FPP Change Form

Change Request Number: 11 IHR 001 Table IHR-4 Unit Operating Priority

Location of Change: Section 6 Ice Harbor, pg. IHR-17 and 18.

| MAIN ONE LINE DIAGRAM | | | |

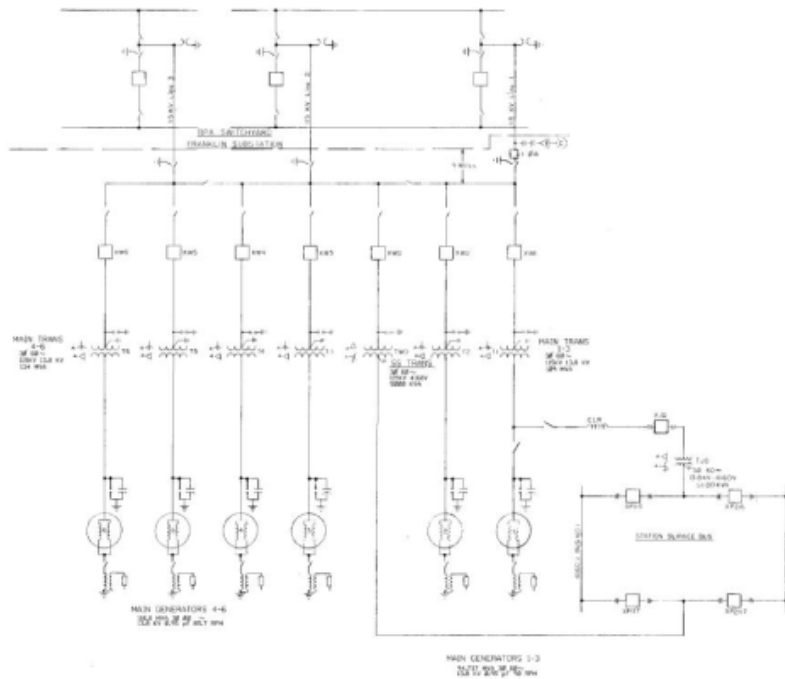
Add the following additional language to table IHR4 Unit Operating Priority for Ice Harbor Dam to clarify operations when Unit 1 is out of service.

In order to provide BPA system reliability Ice Harbor is operationally restricted to single unit operation on Ice Harbor-Franklin No. 1 115kV line and the Ice Harbor-Franklin No. 3 115kV line only. Ice Harbor cannot operate a single unit on Ice Harbor-Franklin No. 2 115kV line. The operation of a single unit on Ice Harbor-Franklin No. 2 115kV line jeopardizes BPA system reliability. If single unit operation is necessary and switching has not occurred in the yard run unit 1, 2, 5, 6. Running units 3 and 4 alone on the Ice Harbor-Franklin No. 2 115kV line can only occur if the powerhouse operator can accomplish the needed switching. If unit 1 is out of service then unit priority will be 2, 3, 5, 4, and 6, in order to limit the number of units out of service due to switching.

Reason for Change: As currently worded when unit 1 goes out of service (OOS) then, 3, 4, 5, and 6 need to go OOS in order to do the required switching from the Ice Harbor-Franklin No. 2 115kV line to the Ice Harbor-Franklin No. 3 115kV line, and unit 2 is the only unit available during the switching time. The required switching takes a significant

amount of time and coordination. Furthermore switching introduces the risk of equipment failure due to mechanical problems or human error. Since Ice Harbor is a single operator plant on nights and weekends this compounds the risk associated with switching. Switching involves risk and for short term outages this risk is not justified whereas if the project deems a longer term outage then the project would deem the risks associated with switching appropriate.

| Season | Time of Day | Unit Priority* |
|--|--------------|--|
| March 1-November 30 | 24 hours/day | 1,3,4,2,5 and 6 (If unit 1 is out of service, and switching has not occurred then operate the following unit priority when operating more than one unit: 2,3,5,4,6) |
